Value Engineering For Transportation Improvements

SR 429 (Wekiva Parkway)/SR 417 and I-4 Interchange

Value Engineering Study Final Report

Project Description: Wekiva Parkway/SR 417 and I-4 Interchange

RECOMMENDATION No. 20: Create a grade separated Diverging Diamond Interchange

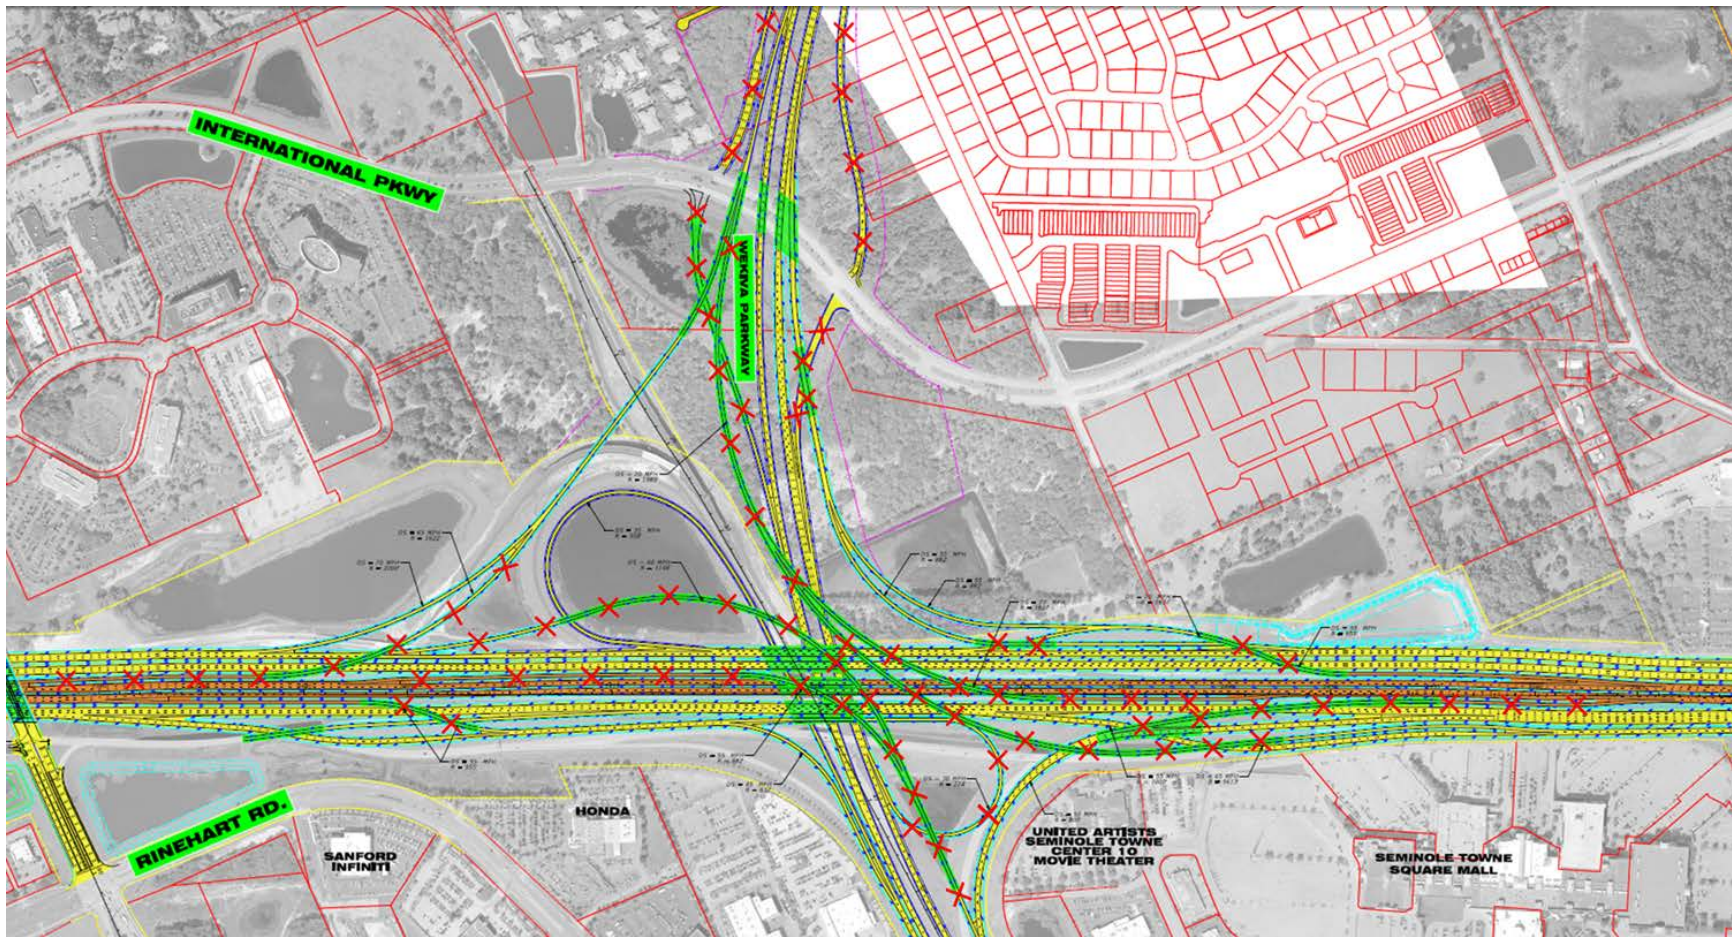
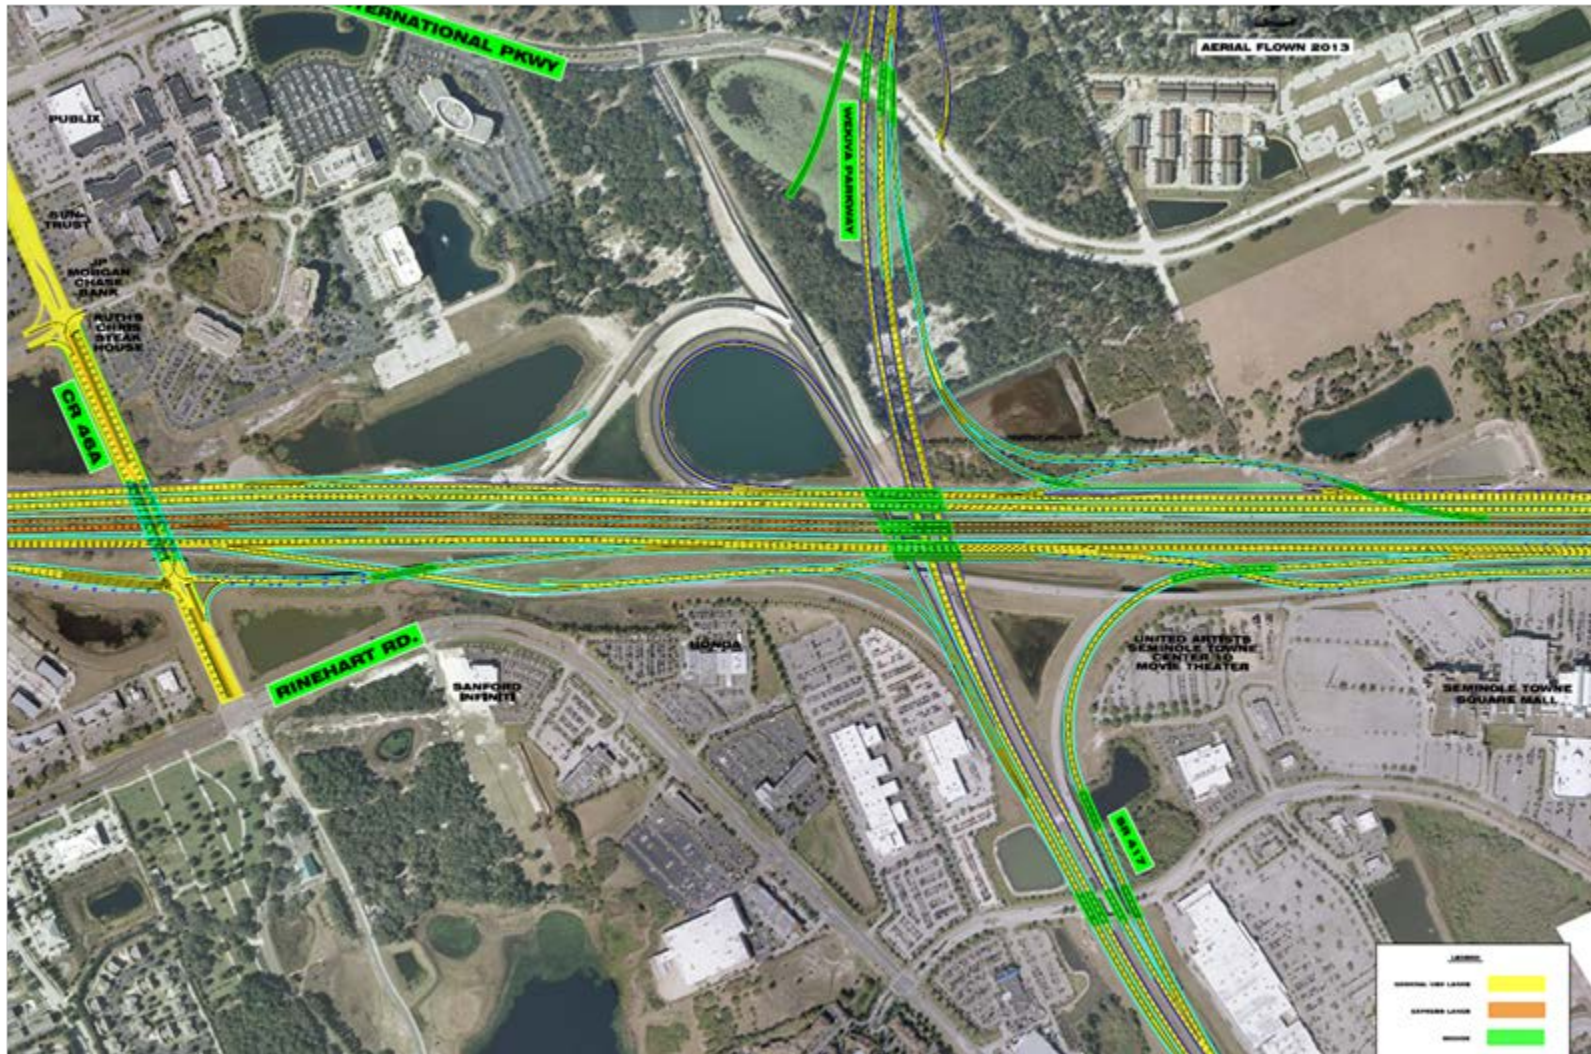
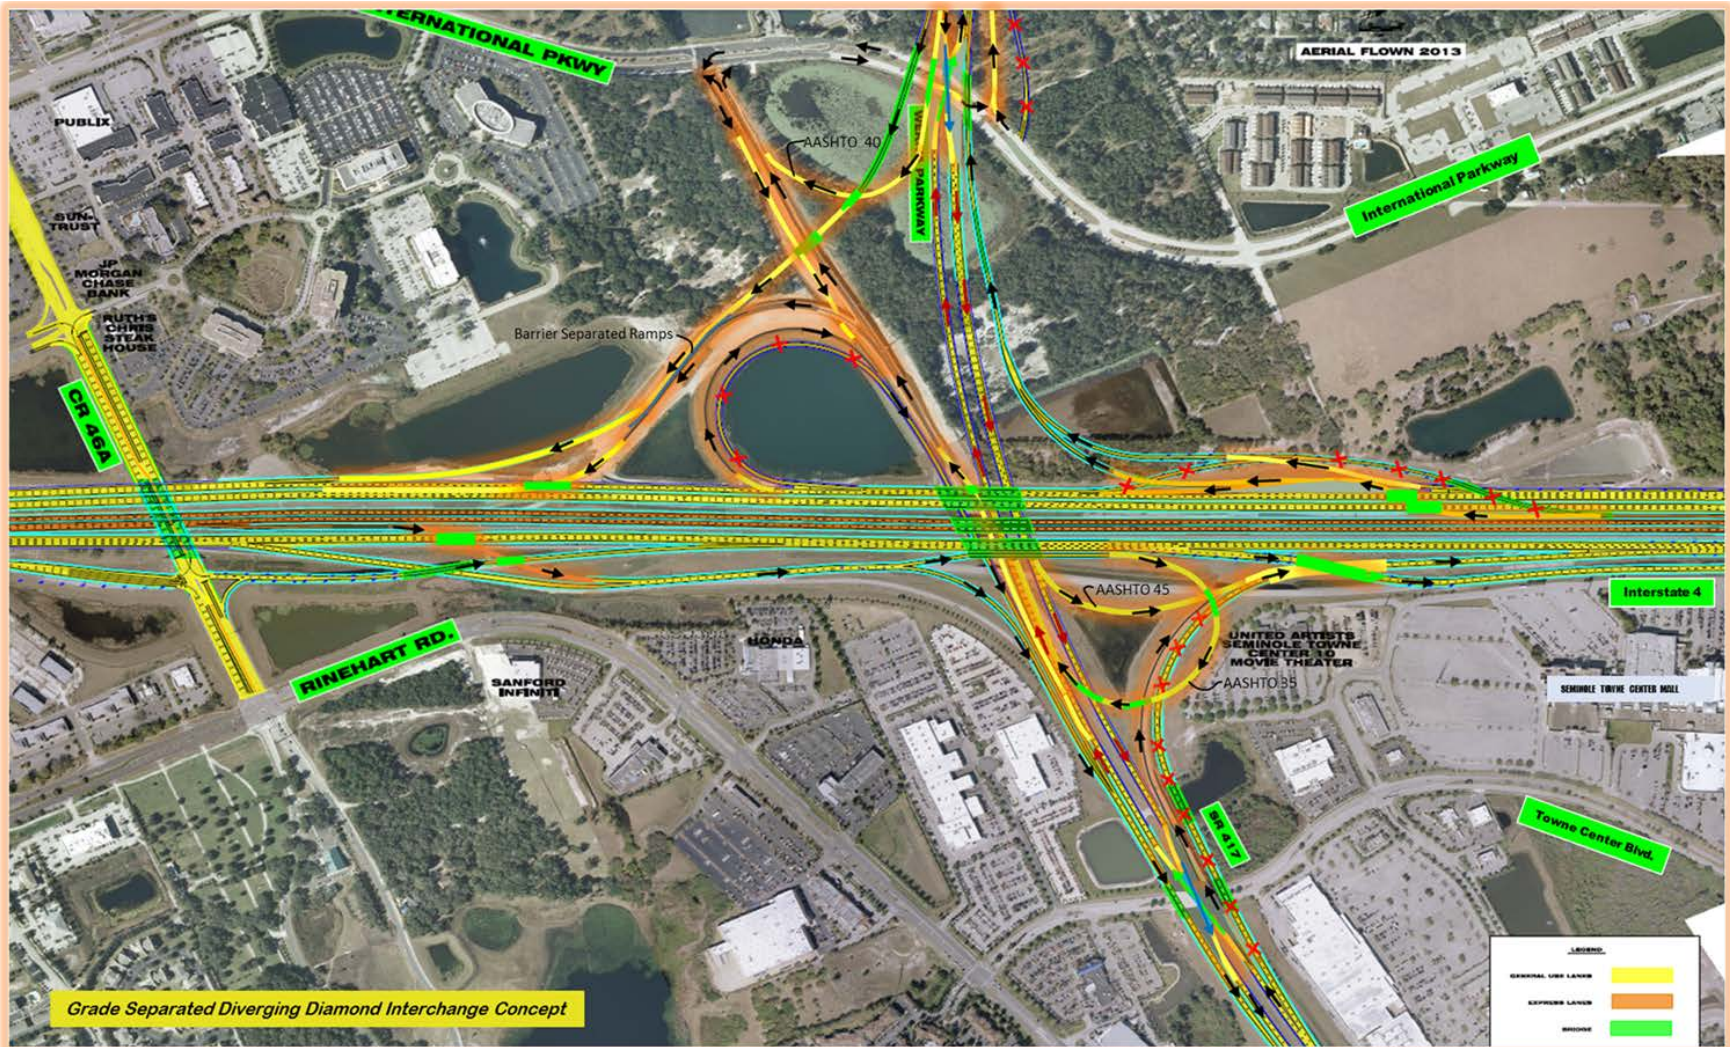
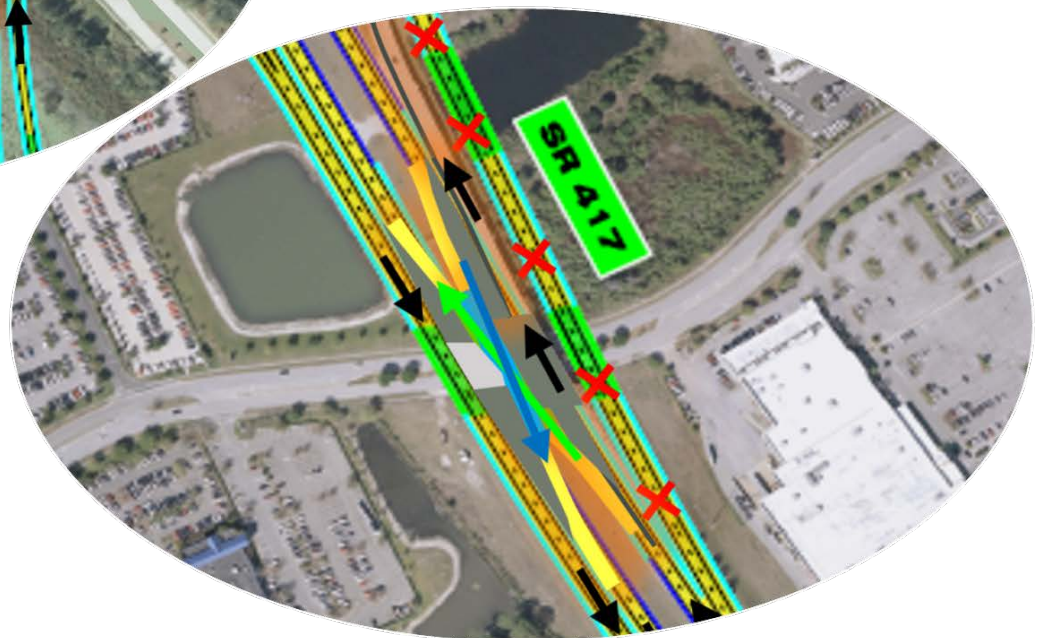
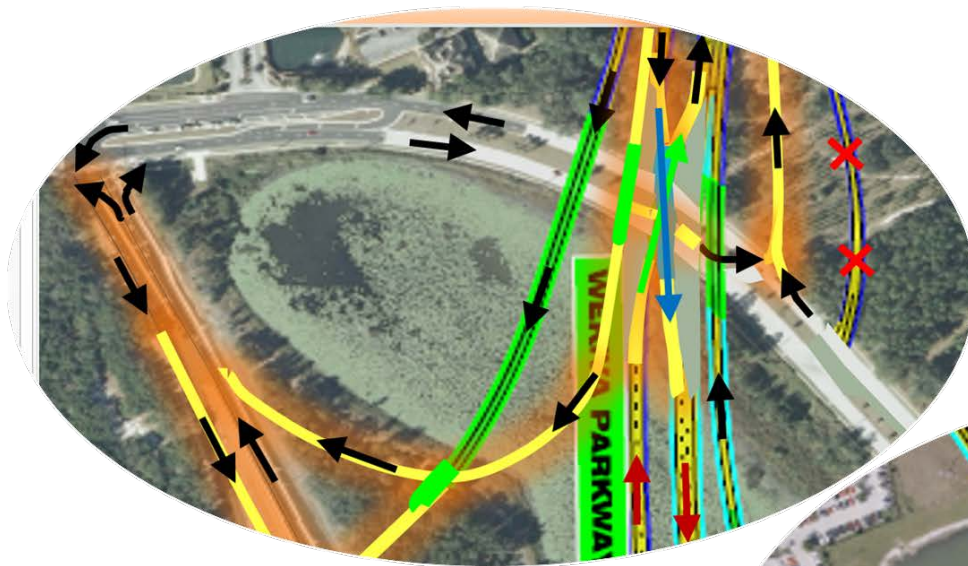
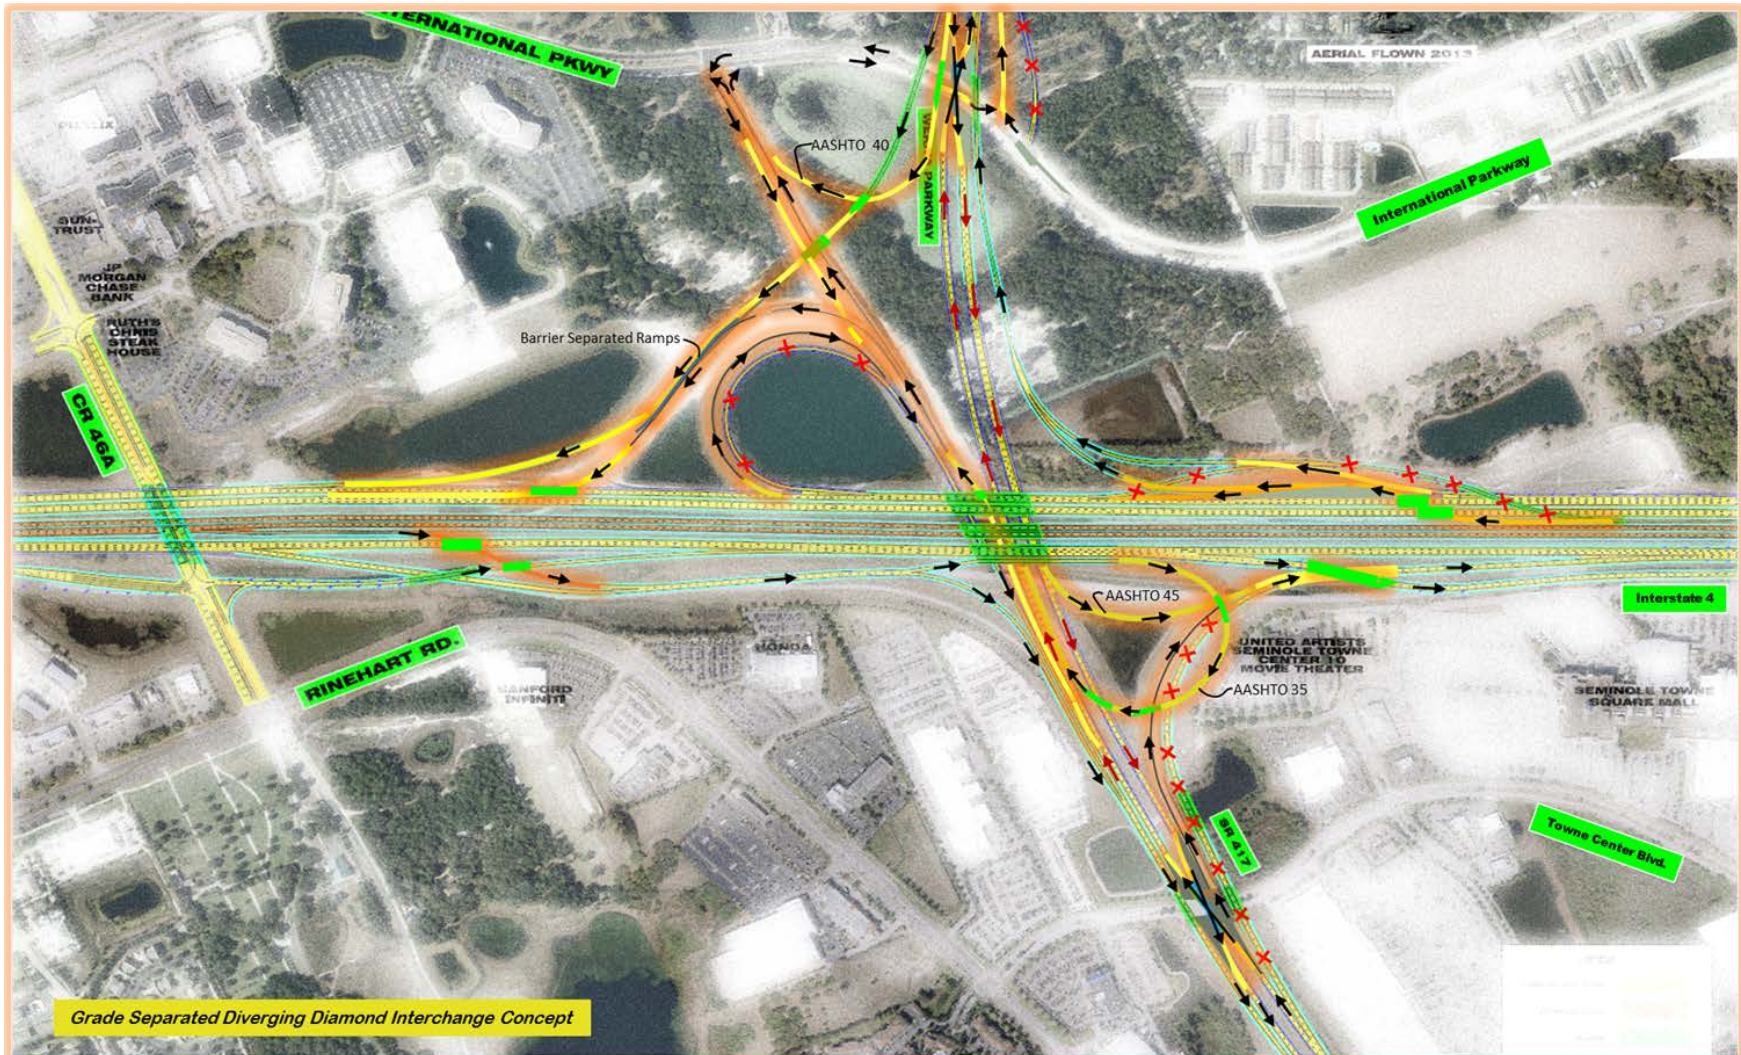
The PD&E Documents show a system to system multi-level direct connect interchange providing full connectivity, including major 3rd level flyover structures eastbound Wekiva Parkway to eastbound I-4 and westbound SR 417 to westbound I-4.

RECOMMENDATION No. 21: Reconfigure the International Parkway and Wekiva Parkway interchange to a tight diamond interchange and move the bridged ramp connections to the outside.

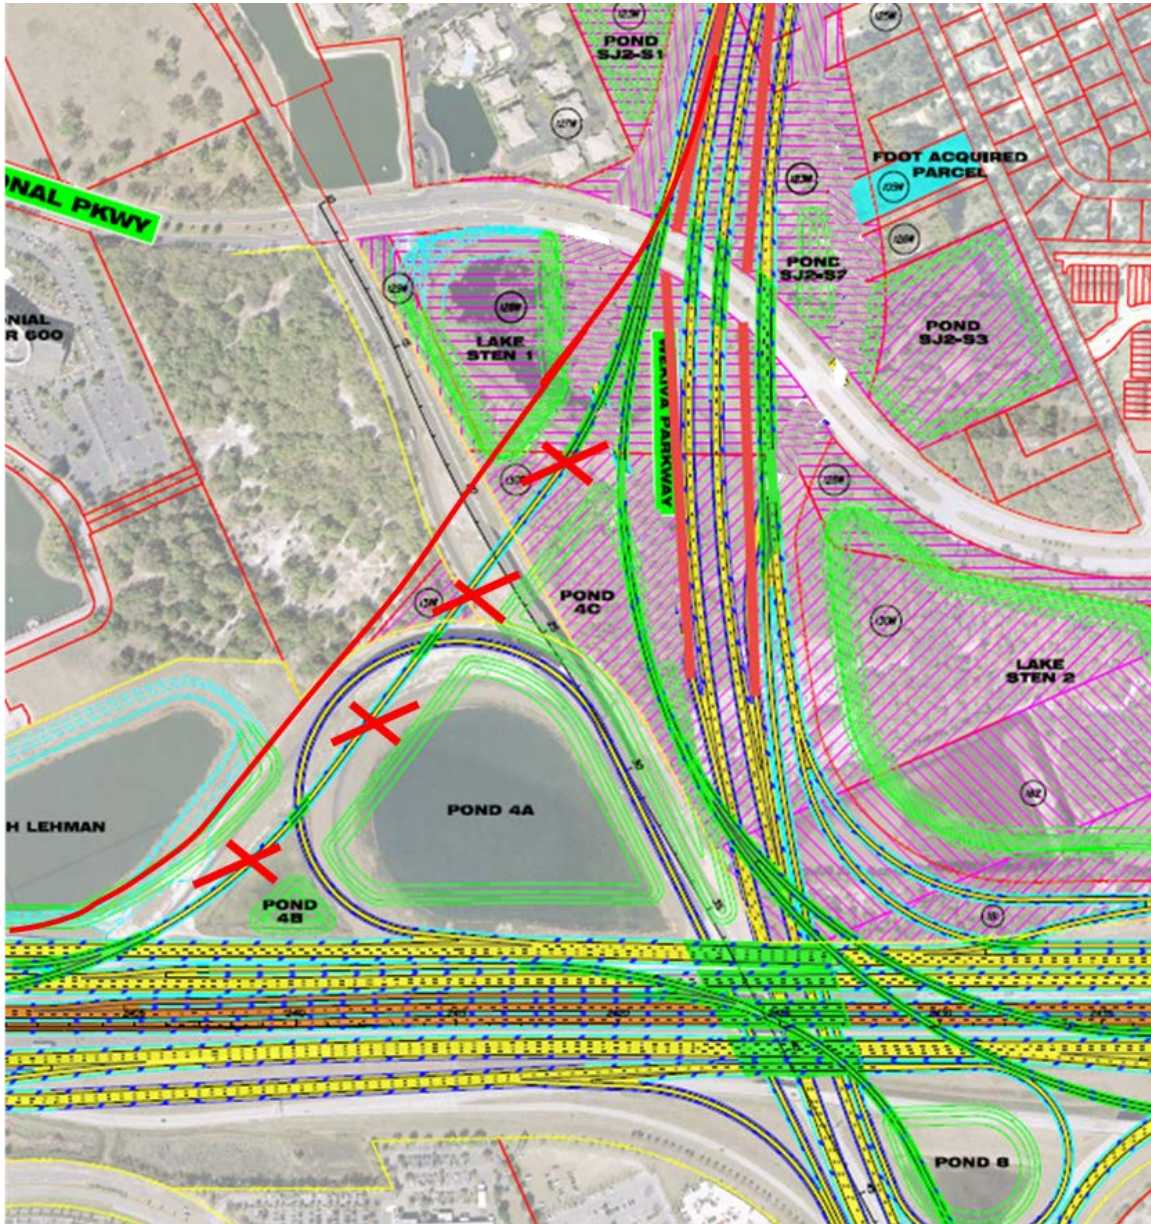
The PD&E Documents show the bridge ramps that intersect with International Parkway as being spread out over the general area impacting the wetlands and requiring additional right-of-way near International Parkway.
